Access Compliance Report

Public Rights-of-Way

(Curb Ramps)

Intersection ID: 9579	Main Street: BANCROFT_ST	Cross Street: FRANKLIN_AV	Location:	S
ADA ID: F3025811C90A	Ramp Type: Directional1	Initial Pass/Fail: Pass	Overall Compliance: No	Severity Score: 7.5
Codes/Mitigation Info/Possible Solution		Field Measurements/Component Compliance

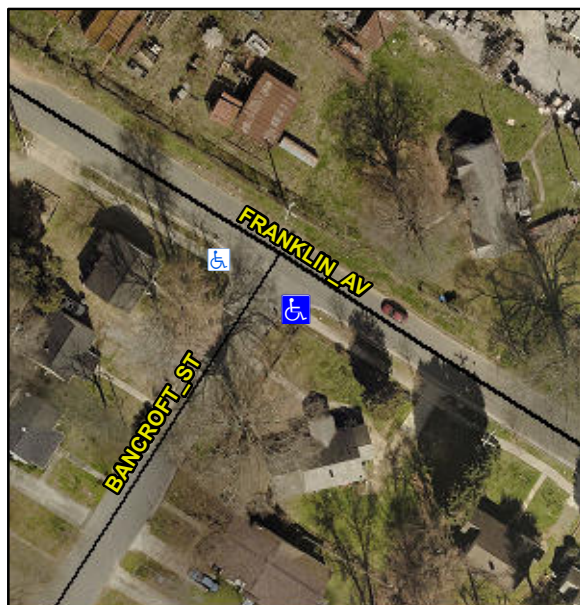
R304.2.1, R304.5.3, R305.1.4, R305.2, R304.5.4

Compliance	Description	Data	Compliance	Description	Data
N/A	Ramp Length (in)	123.0	Yes	Grade Break?	Yes
Yes	Ramp Width (in)	59.0	No	Grade Break Slope (%)	7.7
Yes	Ramp Slope (%)	6.8	Yes	Grade Break XSlope (%)	1.2
Yes	Ramp XSlope (%)	1.4			
N/A	Flare Type LT	N/A	N/A	Flare Type RT	N/A
N/A	Flare Slope LT (%)	N/A	N/A	Flare Slope RT (%)	N/A
N/A	Flare Traversable LT?	N/A	N/A	Flare Traversable RT?	N/A
No	Landing Length (in)	44.0	Yes	DWS Provided?	Yes
Yes	Landing Width (in)	60.0	Yes	DWS Contrast?	Yes
Yes	Landing Slope (%)	1.2	Yes	DWS Length (in)	24.0
No	Landing X Slope (%)	2.1	No	DWS Full Width?	No
N/A	Landing Curb? (Y/N)	N/A	No	DWS Offset LT (in)	4.0
N/A	Shared Landing?	No	Yes	DWS Offset RT (in)	45.0
Yes	Gutter Ponding?	No	No	Gutter Slope (%)	5.3
Yes	Gutter Lip Ht (in)	0.0	No	Gutter X Slope (%)	3.0
N/A	Painted X Walk1?	No		Road Slope (%)	1.4
	X Walk 1 Direction	To NW		Road X Slope (%)	2.8
	X Walk 1 Width (in)	N/A		Clear Space?	Yes

X Walk 1 Slope (%)	1.4	N/A	Clear Space to XWalk (in)	N/A
	X Walk 1 X Slope (%)	2.8	Yes	Storm Grate/Utility Hazard?	No
N/A	Ramp inside XWalk1?	N/A		Storm Grate/Utility Type	
Yes	Any Obstructions?	No			N/A
	Obstruction Type		Yes	Surface Condition? (G/P)	Good
			N/A	Curb Slope (%)	N/A

Remove & Replace Entire Ramp.
Remove & Replace Gutter.
